SERVICE BULLETIN

APPLICABILITY: 2015-2017MY Legacy and Outback
 2012-2016MY Impreza
 2013-2016MY XV Crosstrek
 2015-2016 WRX / WRX STI
 All Models Listed with Seat Lifter Feature

NUMBER: 12-206-16
DATE: 07/28/16

SUBJECT: Seat Cushion Frame Surface Rust Treatment Procedure

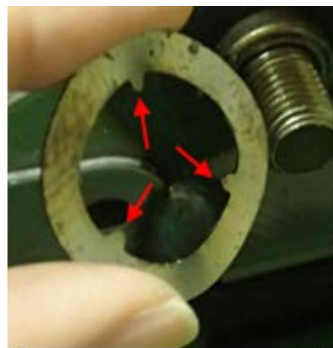
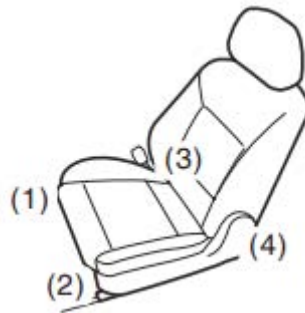
NOTE: If the wave washer used for the seat belt buckle is found to be the old “tang” type, replace it with the new style washer **p.n. 64168SG000** as shown in the photos below.

OLD Wave Washer

NEW Wave Washer
